## **Request for Class II Permissive Change**

FCC ID: VG8EM925AYY Data: 2012-7-20

Please be notified that we, the undersigned, Guangdong Midea Microwave and Electrical Appliances Manufacturing Co.,Ltd. declare that the reasons for this class II permissive change are as below:

Mother board with switching power supply (MD1001LSB)

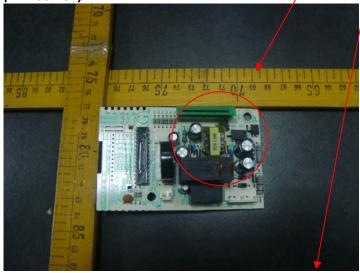
Changed linear transformer to the following two switching power supply(MD1001LSB and MD1001LB).

- 1. Two switching power supply have the same electric specification&circuit function, only PCB layout and component's location are different.
- 2. Between linear transmitter and switching power supply have the same specfications of rated output power, Changed to the switching power supply, rated output power have not obvious changes.
- 3. Mother board MD1001LSB was selected for the final testing.
